AUTOMATIC TRANSMISSION SERVICE GROUP

"VOLUME II"

Since the introduction of the THM 440-T4 (4T60) Transaxle in April, 1984, there have been MANY major engineering design changes. These changes have affected nearly every part used in the THM 440-T4 (4T60).

This version, "VOLUME II", of the 440-T4 "Update Handbook" begins with the engineering design changes that occurred in the 1990 model year and will explain each change, the parts affected by the change, any parts interchange problems created by the change, and will be revised as necessary.

Figure 33

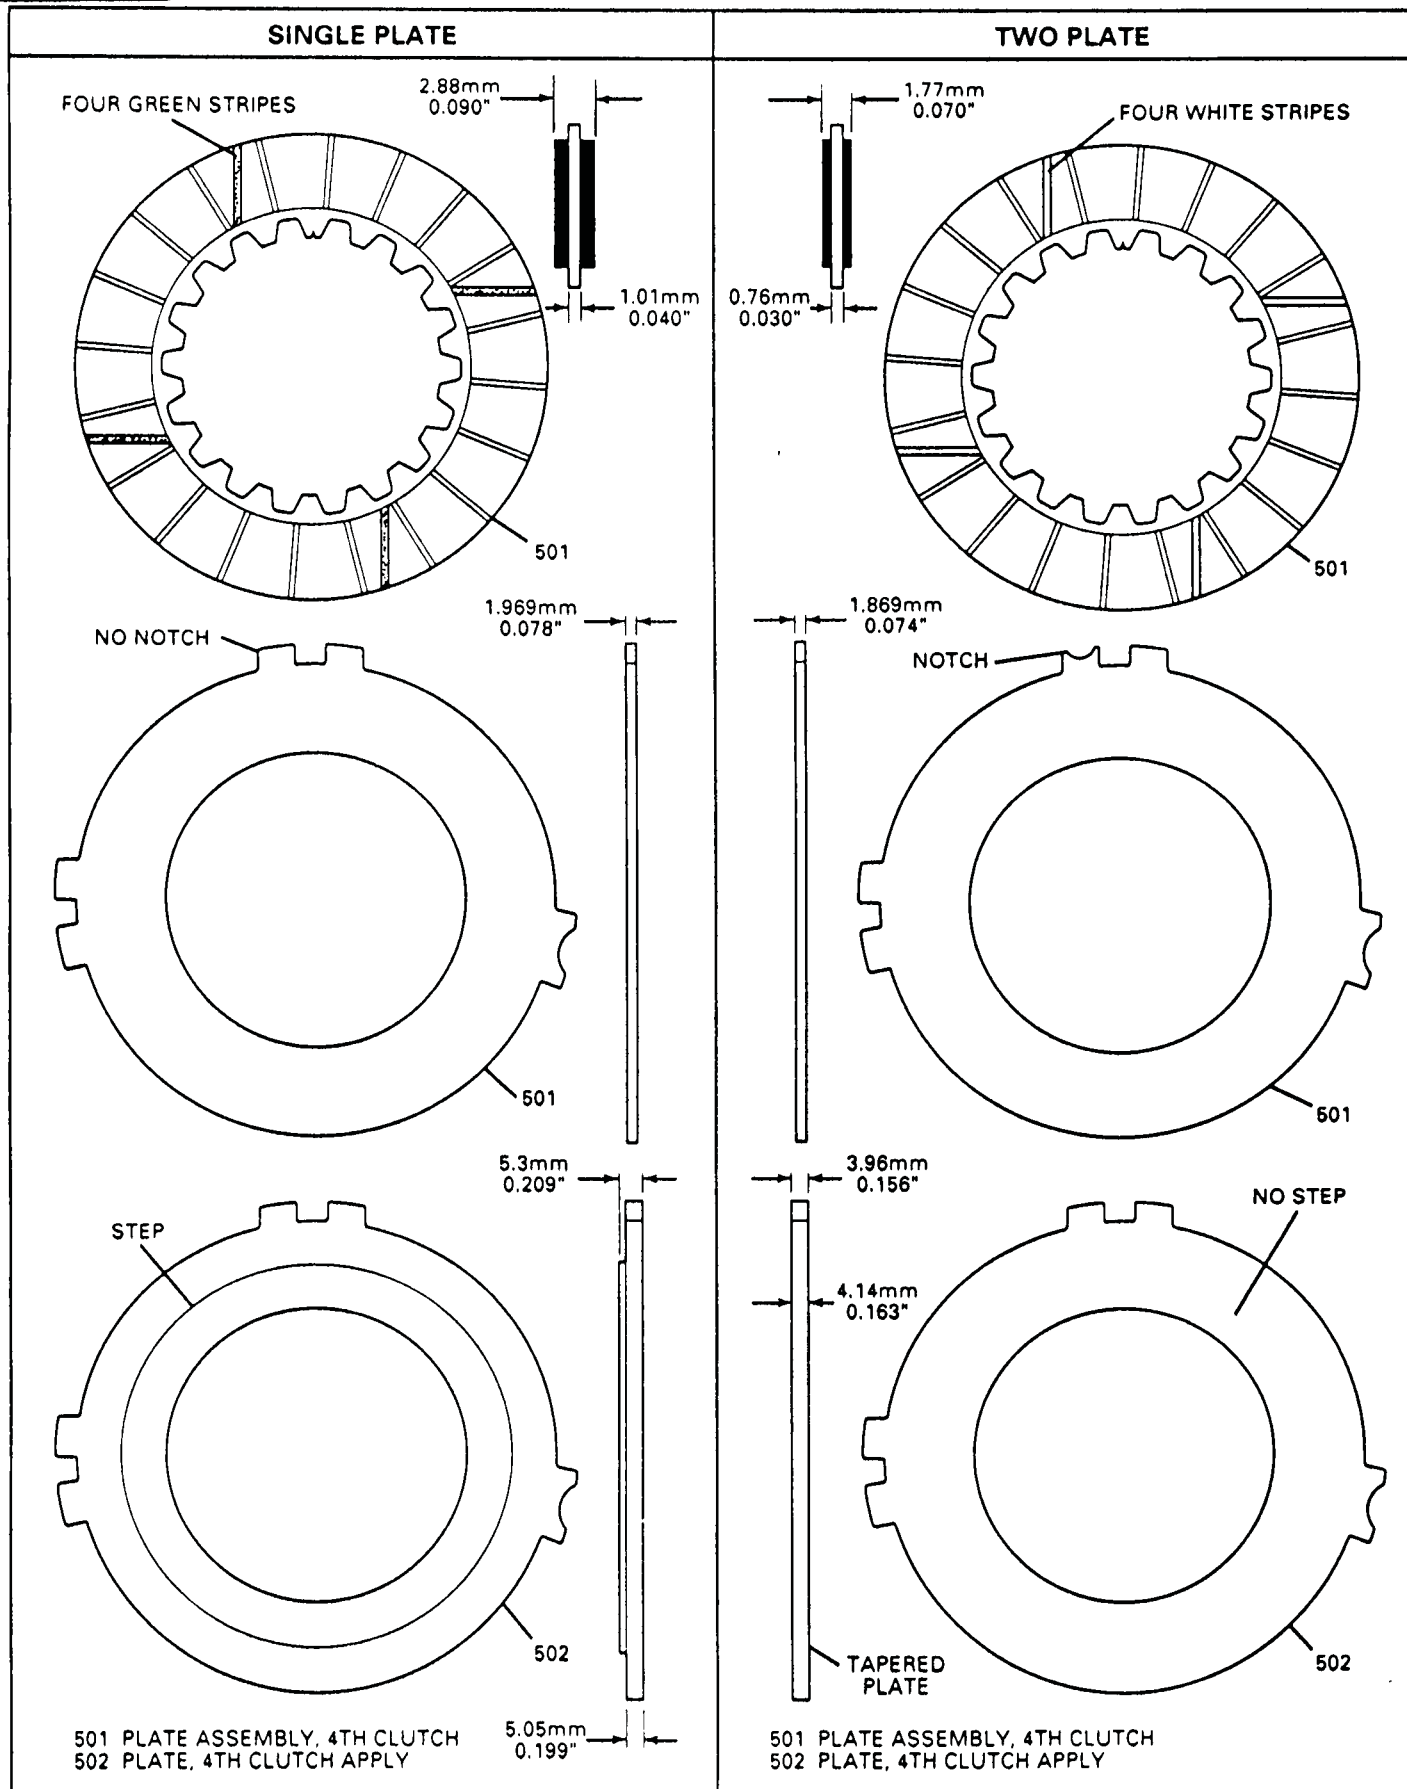
CHANGE: A new "Two Plate" 4th clutch assembly was used to replace the Single Plate 4th clutch assembly for SOME MODELS ONLY on the 1990 THM 440-T4 transaxles (See Figure 33).

- (1) 4TH CLUTCH LINED PLATES - Were made thinner by .020" than the previous lined plate, and can be identified by the four WHITE stripes, while the single plate lined plate has four GREEN stripes (See Figure 33). The Single Plate 4th Clutch is .090" thick, and the new "Two Plate" 4th Clutch plates are .070" thick.
- (2) 4TH CLUTCH STEEL PLATES - Were made thinner by .004" than the previous plates, and can be identified by a "Notch" cut into one of the tabs (See Figure 33). The single plate 4th clutch steels are .078" thick, and the new "Two Plate" steels are .074" thick.
- (3) 4TH CLUTCH APPLY PLATE - Was machined thinner than the previous apply plate, and the step was removed. Refer to Figure 33.

Will not interchange without calibration changes. May create harsh shifts if the Two Plate type is installed where the Single type was, or soft shift if the Single type is installed where the Two Plate type belongs.

Figure 35

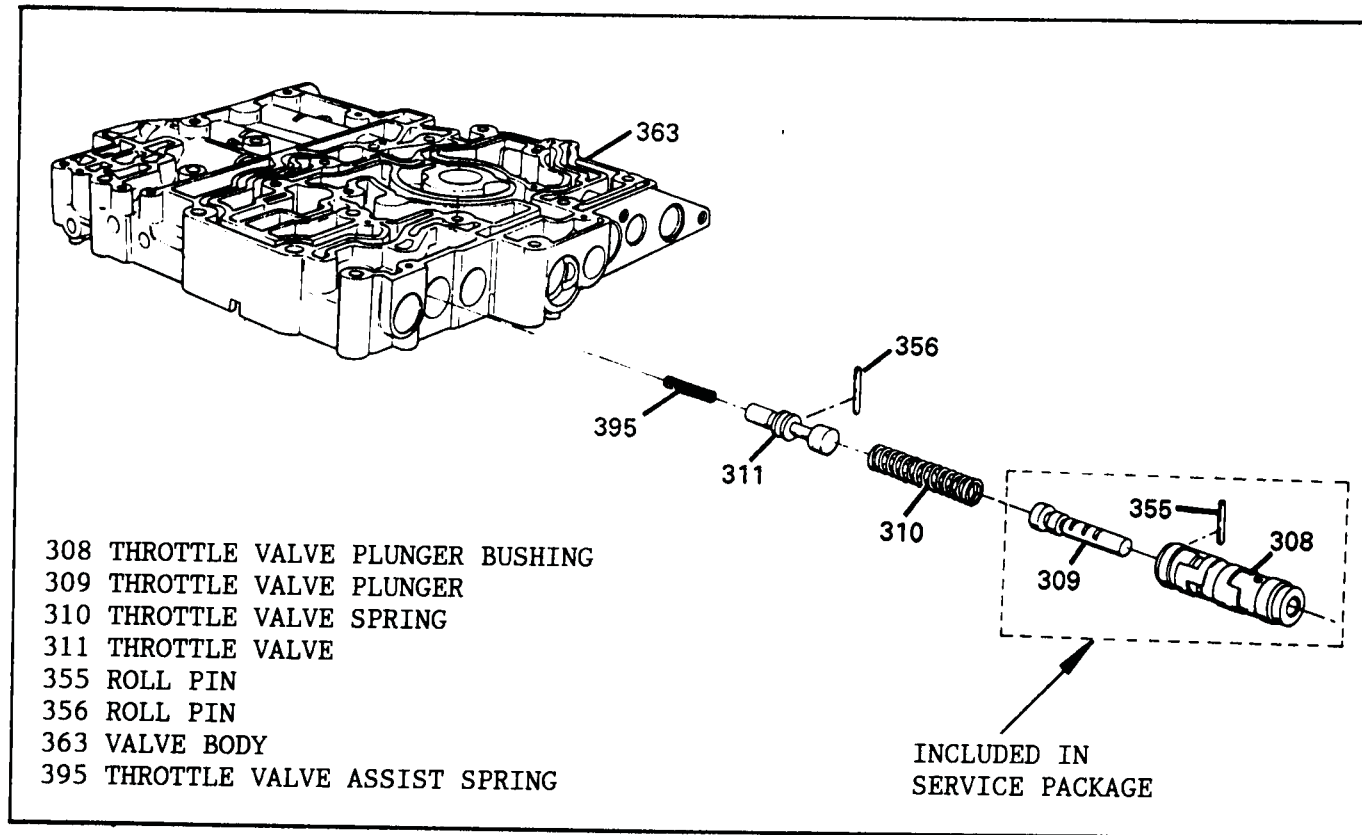
The T.V. Plunger and Bushing Assembly are now available from OEM in a service package, so that buying a valve body is no longer necessary when the TV plunger is broken or cracked (See Figure 35). Refer to the following OEM part numbers as it IS a model sensitive part.

Figure 37

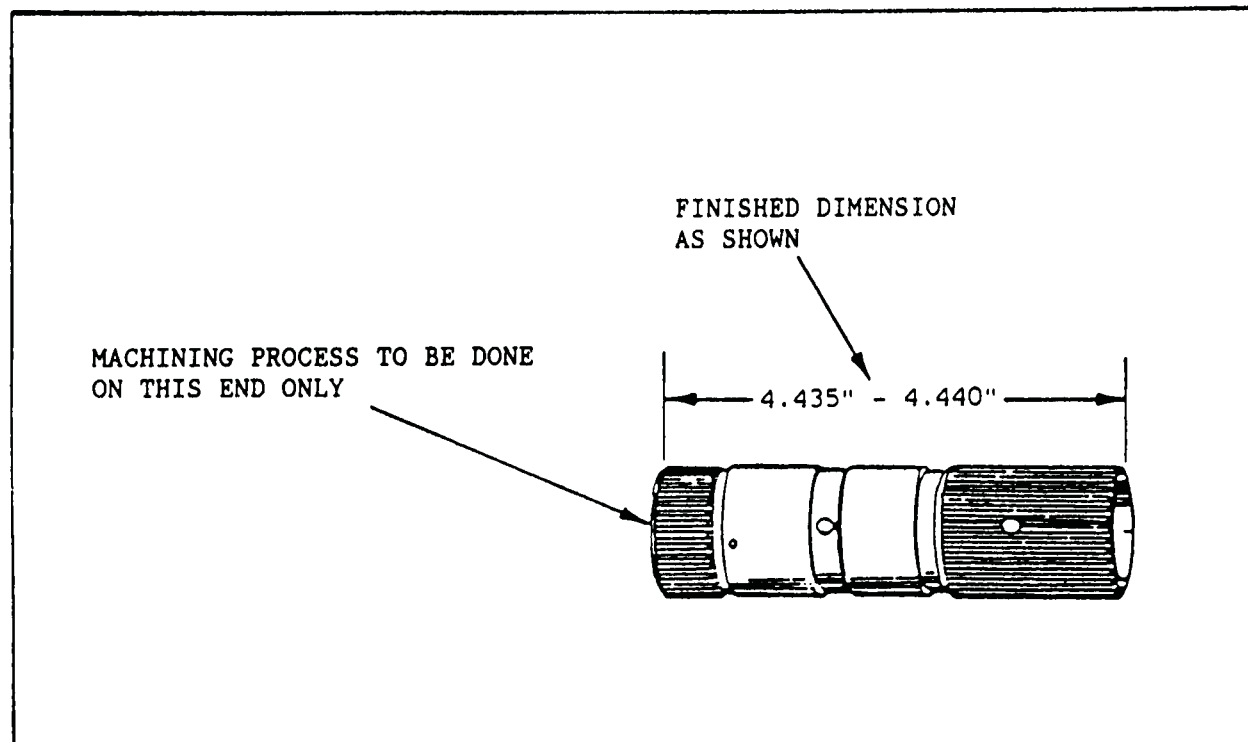
COMPLAINT: Plastic Lube Dam located between the carriers, in two pieces, appearing as if it had been machined. Sometimes not machined all the way through.

CAUSE: Final drive sun gear shaft is too long, and cuts or machines plastic lube dam in half.

CORRECTION: Machine or grind the final drive sun gear shaft, ON THE SHORT SPLINED END ONLY, to the dimension shown in Figure 37. Finished dimension should be 4.435" - 4.440". Non-machined final drive sun gear shaft will measure 4.480" - 4.490".

Figure 39

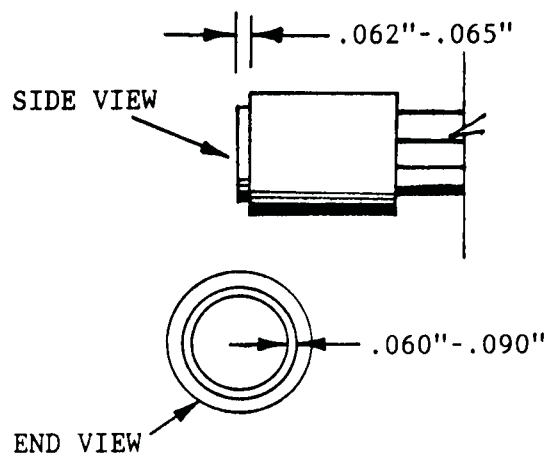
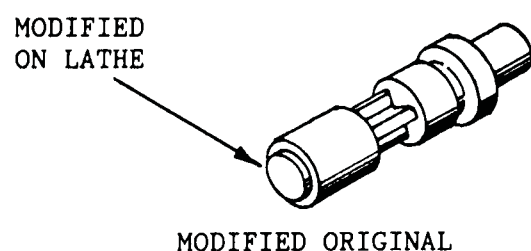
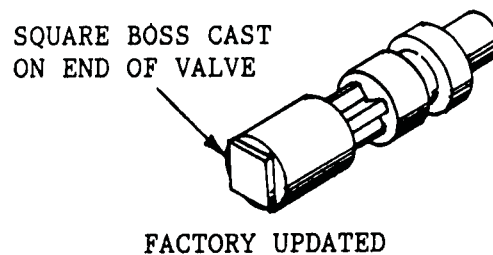
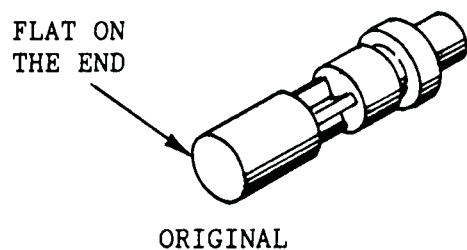
CAUSE: The cause may be the 1-2 shift valve sticking in the upshifted position (See Figure 38). The 1-2 shift valve is aluminum and might have a tendency to "Mushroom", caused by hitting the valve body casting in the bottom of the bore.

CORRECTION: Modify the original 1-2 shift valve as shown in Figure 39. This is a very simple machining operation on a lathe. The factory has upgraded the 1-2 shift valve with a "Boss" cast on the end of the valve (See Figure 39).

THIS MODIFICATION KEEPS THE END OF THE SHIFT VALVE FROM "FLARING OUT" WHEN IT BOTTOMS IN THE BORE.

Figure 40

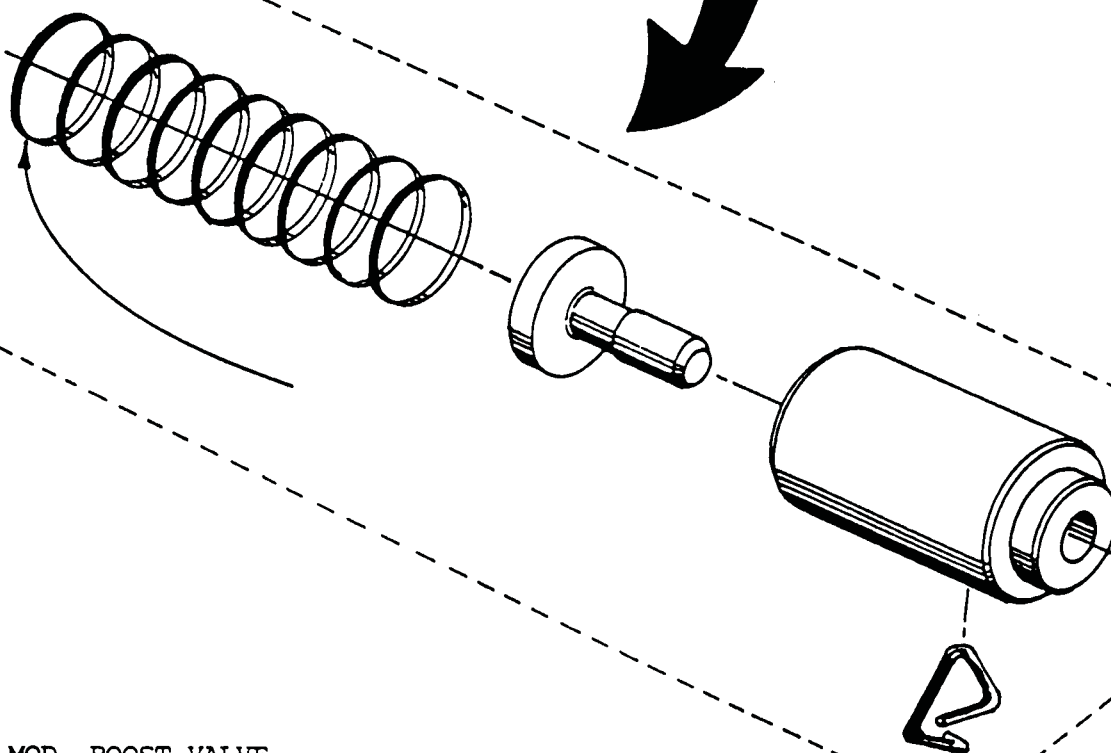
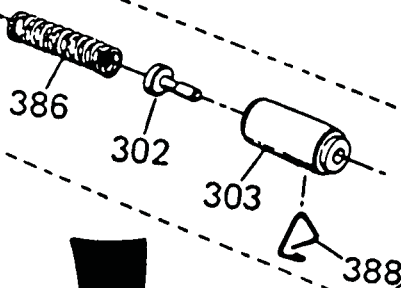
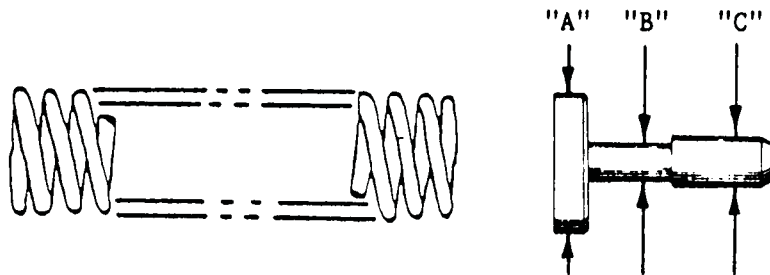
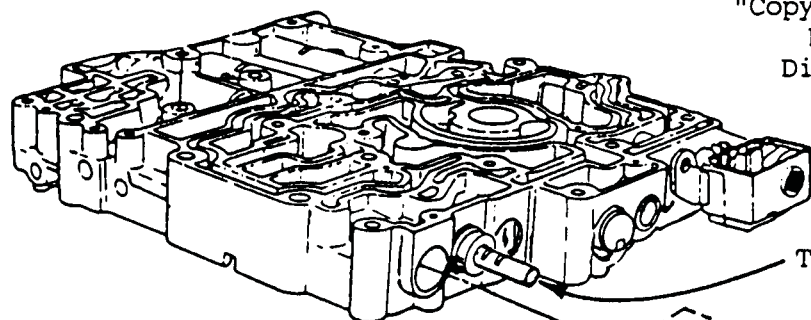
- COMPLAINT:** 2nd clutch pack with a very short life span, usually associated with a 1-2 slip, or a 1-2 slide bump.
- CAUSE:** The cause may be a lack of line pressure rise to sufficiently apply the second clutch pack. We also recommend OEM "Koline" steel plates in this pack, and "Vespel" sealing rings on the driven sprocket support.

- CORRECTION:** Shorten the modulator boost valve spring by 1/4" or approximately 1 to 1 1/2 coils. The modulator boost valve spring is located in the pressure regulator line-up, which is directly next to the T.V. plunger in the valve body (See Figure 40). This will allow line pressure to rise at less of a throttle opening and greatly increase 2nd clutch durability. This modification should be done on "ALL" THM 440-T4 transaxles during the rebuilding process.

Figure 41

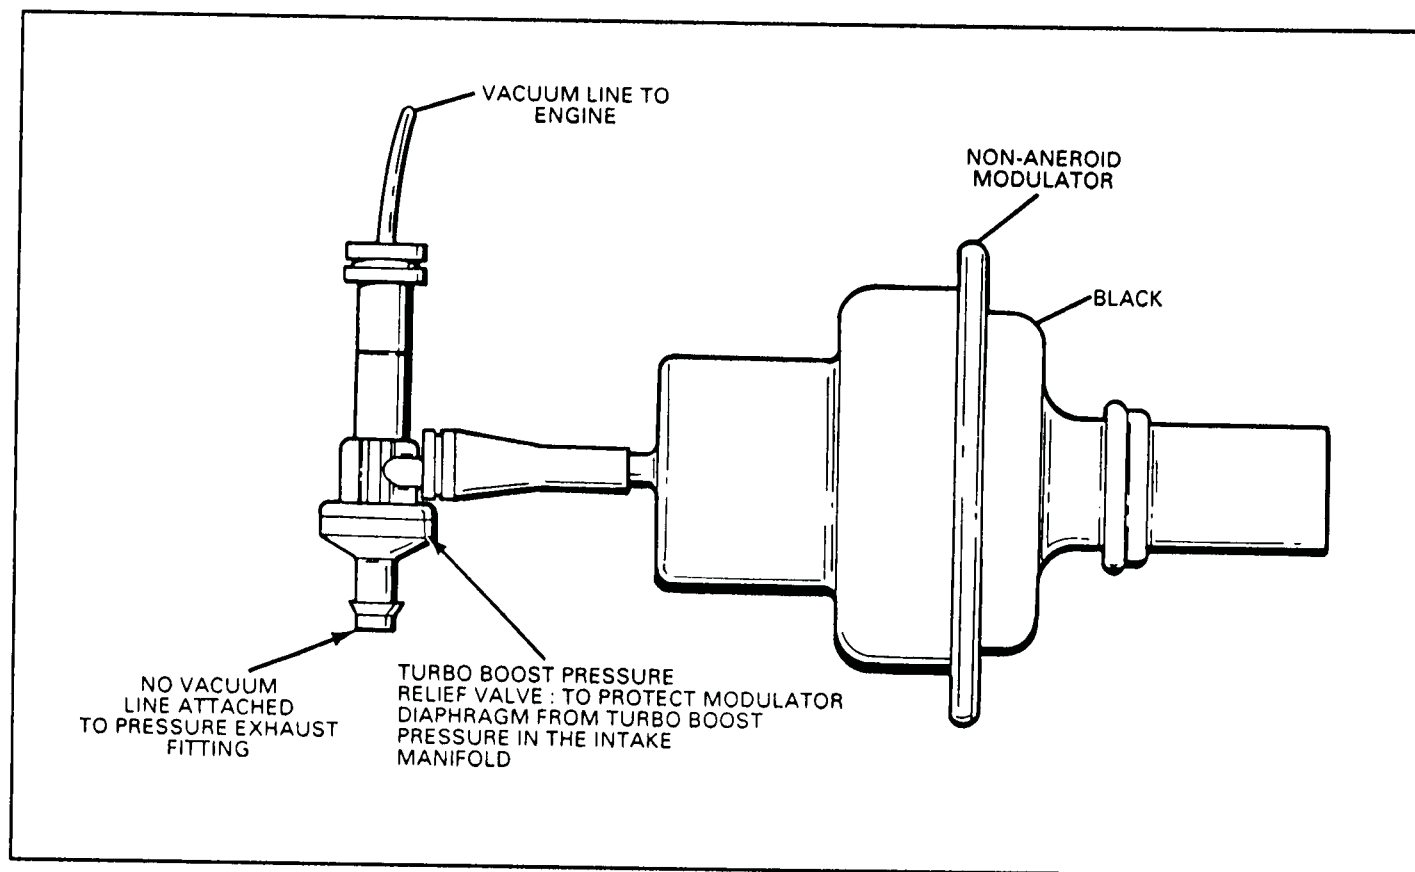
CHANGE: There is now a new Vacuum Modulator, with a Pressure Relief Valve installed between the modulator and the vacuum line to the engine. (See Figure 41).

- (1) VACUUM MODULATOR - Special non-aneroid modulator that is compatible with the 3.1L Turbocharged Engine ONLY. The transmission model codes are OLAH, and OYRH, and found in the "W" car.
- (2) PRESSURE RELIEF VALVE - To protect the diaphragm in the modulator from turbo boost pressure in the intake manifold. This is a "One-Way" valve and must be installed as shown in Figure 41.

NOT INTERCHANGEABLE - FITS TURBOCHARGED MODELS ONLY.
